**CHANGE/ERRATA INFORMATION****ISSUE NO: 4      4/85**

Title: 1953A  
Print Date: January 1975  
Rev.- Date: 4-1/79

Figure 615-11.

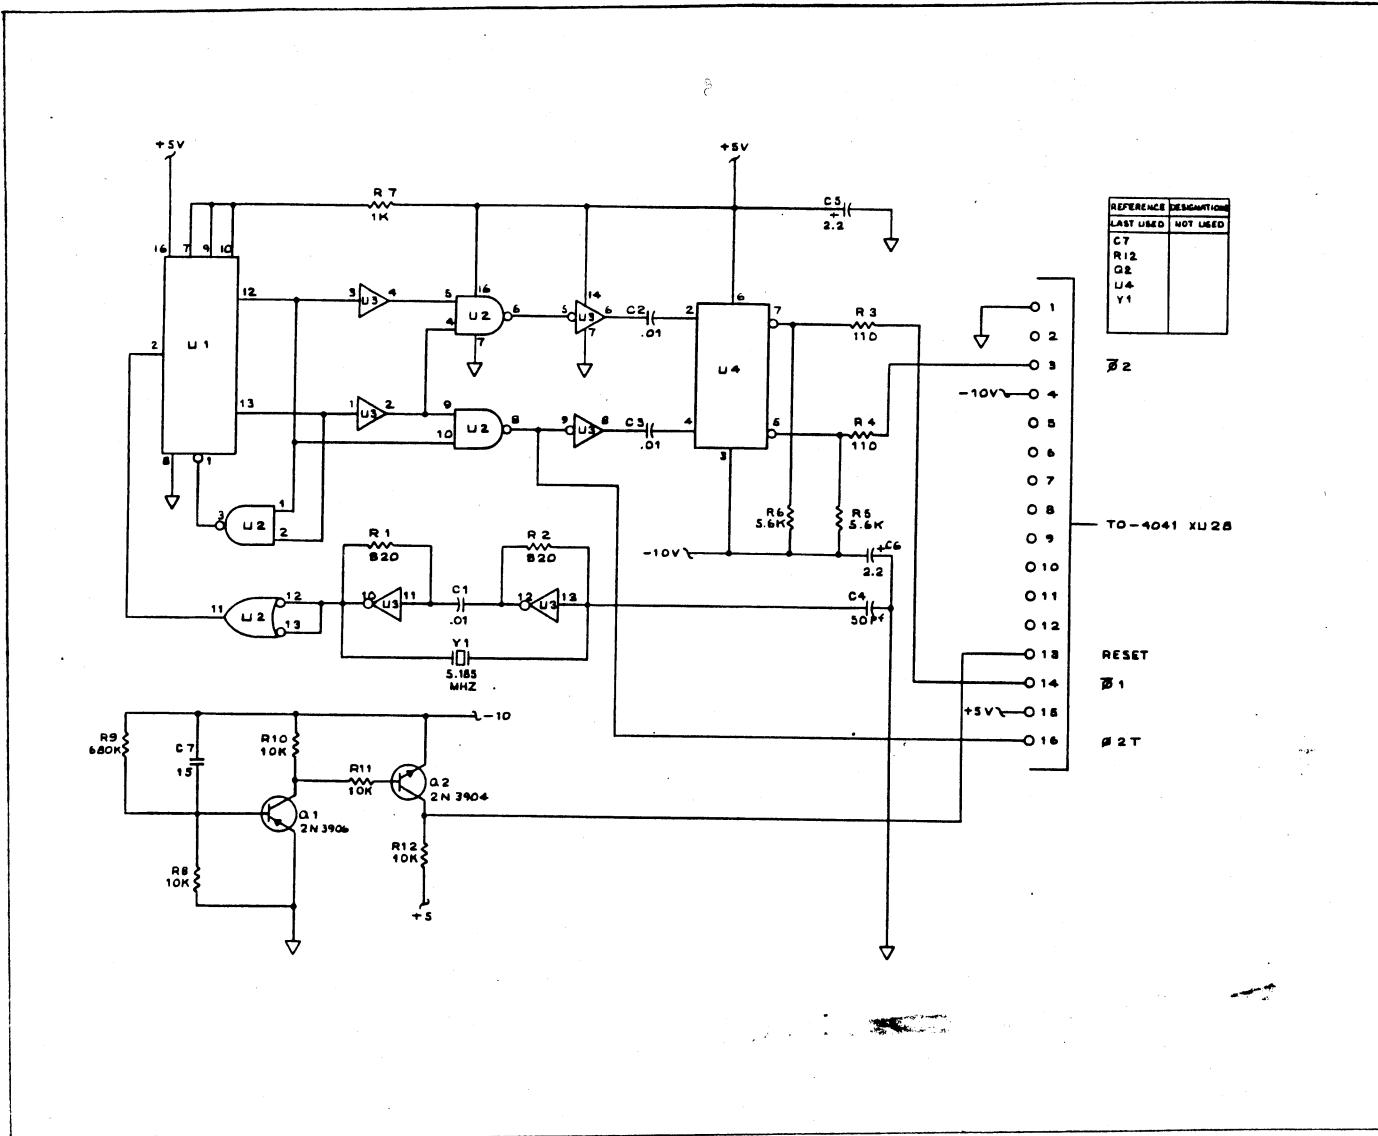
On page 615-16, add Table 615-13a., Figures 615-10 and 615-11.
